HISTORIC AND DESIGN REVIEW COMMISSION

April 03, 2019

HDRC CASE NO: 2019-096
ADDRESS: 808 E CARSON
LEGAL DESCRIPTION: NCB 1266 BLK 2 LOT 2
ZONING: RM-4, H
CITY COUNCIL DIST.: 2
DISTRICT: Government Hill Historic District
APPLICANT: Peggy Brimhall/Figurd
OWNER: 1807 Land & Cattle Co. LLC
TYPE OF WORK: Amendment of a previously approved design regarding window materials
APPLICATION RECEIVED: February 18, 2019
60-DAY REVIEW: April 19, 2019
CASE MANAGER: Edward Hall
REQUEST:

The applicant is requesting a Certificate of Appropriateness for approval to amend the previously approved design regarding window materials. The applicant has proposed to install aluminum windows in lieu of the previously approved aluminum clad wood windows.

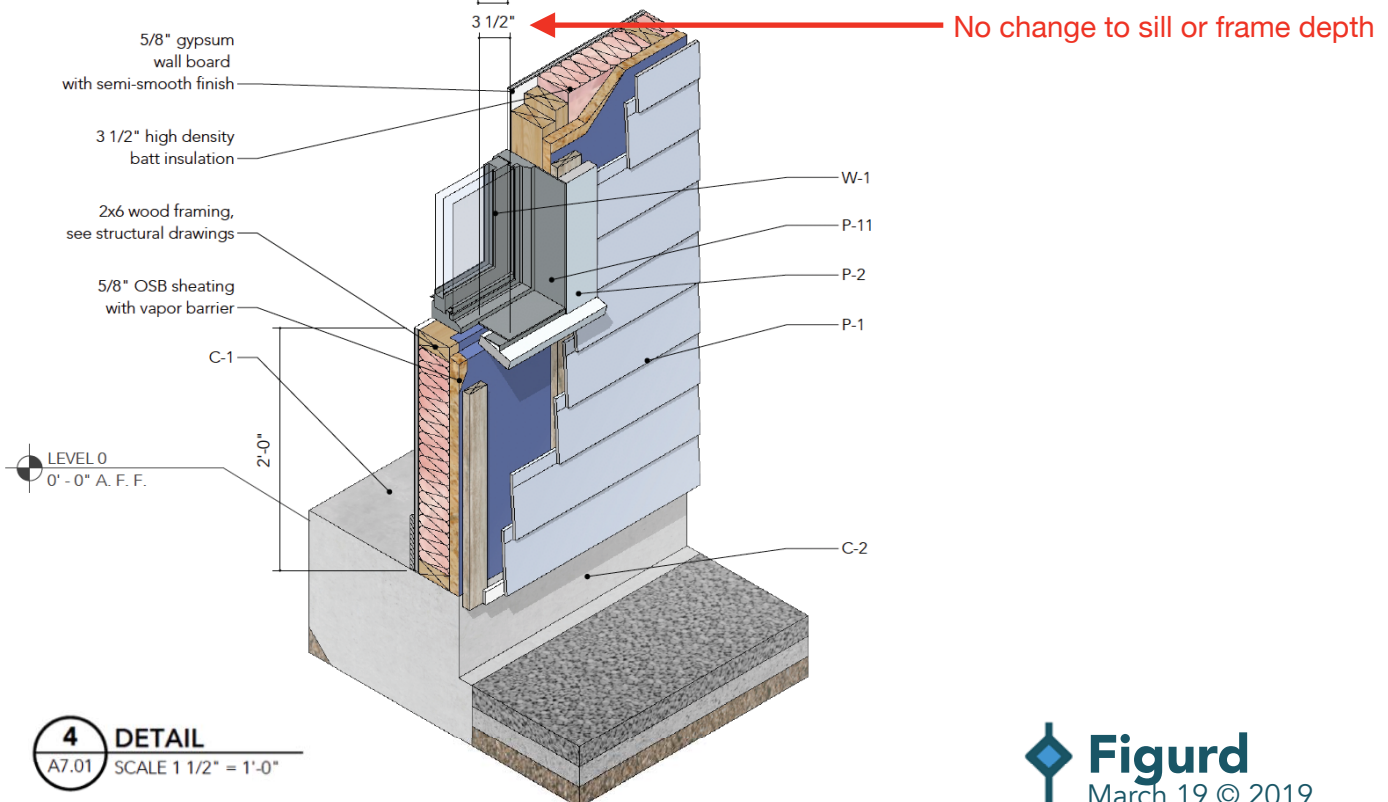
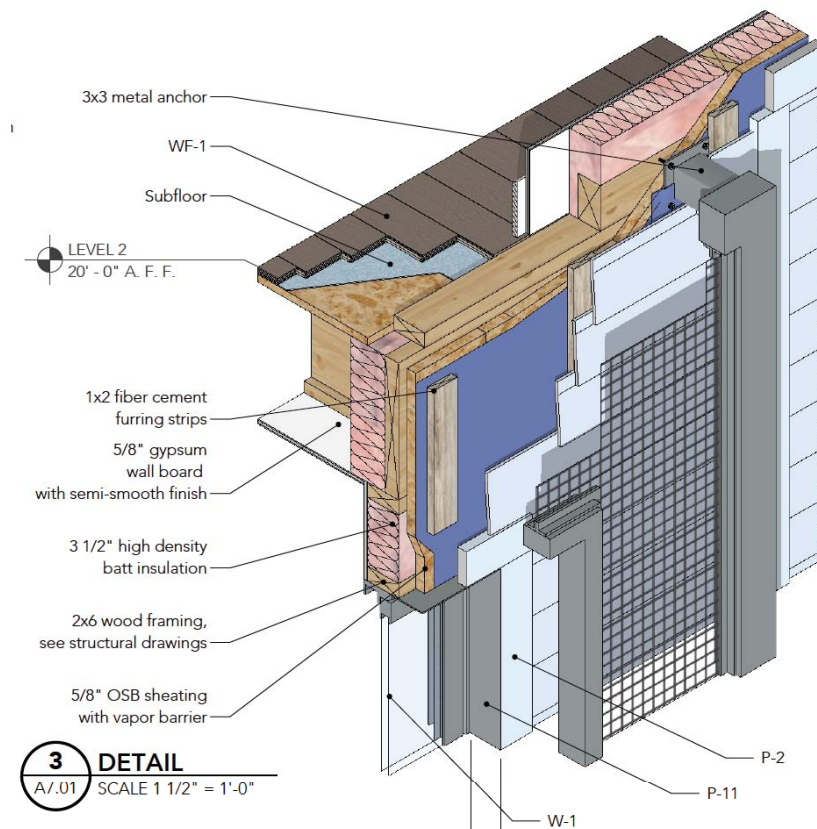
No Change to Sill and Frame design
